Service Bulletin

Subject: McDonald's Intuition MIE314 Cord set Impingement

Models: Frymaster McDonald's MIE314 Intuition Electric Fryers with serial numbers prior to 2610.

Figure 1

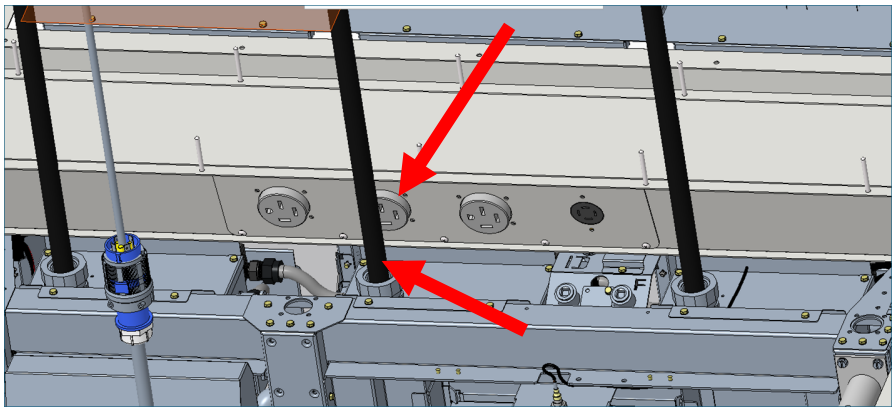
Some McDonald's MIE314 Intuition electric fryers middle cord position, may interfere with the receptacle on the race way, that **use universal hoods** (see Figure 1).
